**Economic Commission for Europe**

**Group of Experts on European Agreement Concerning Work of  
Crews of Vehicles Engaged in International Road Transport (AETR)**

**Annex 1C**

<p><b>LIST OF PROPOSED CHANGES TO ANNEX 1C FOR AETR V0.2 20190116</b></p>
--	---

Current image in CSM\_010

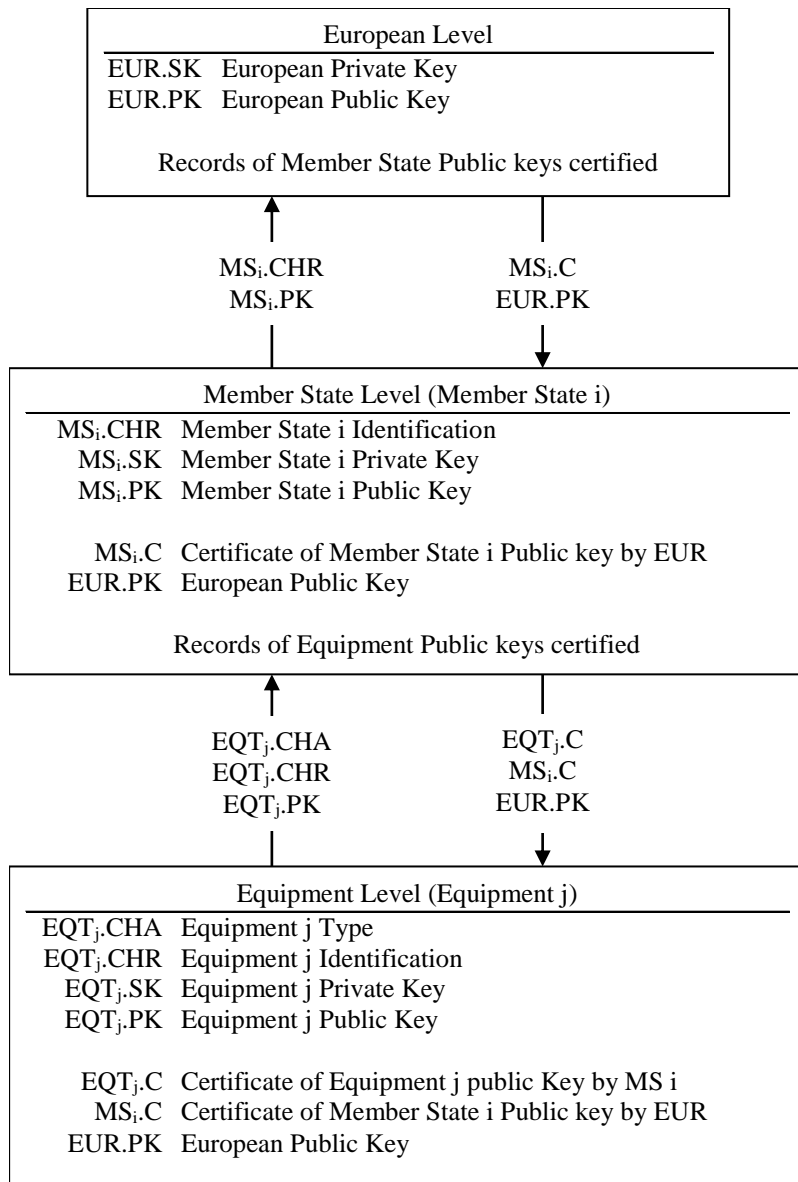
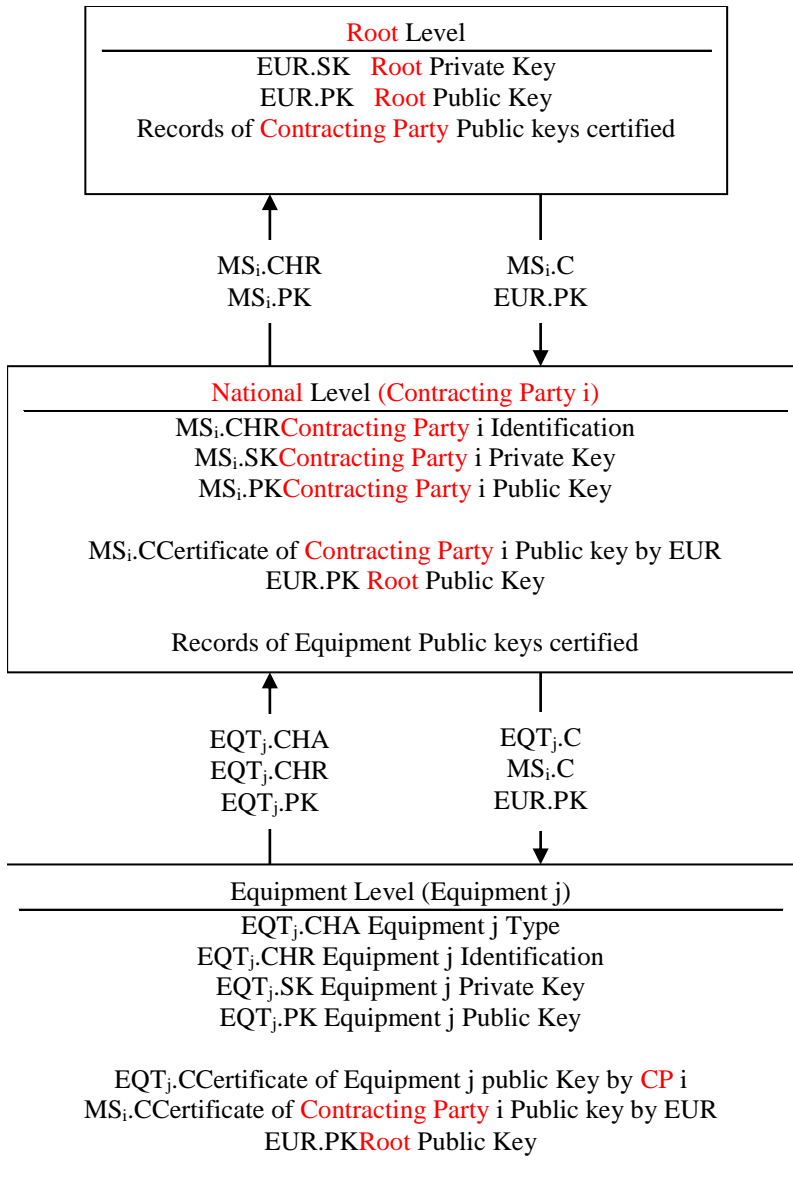
New proposed image
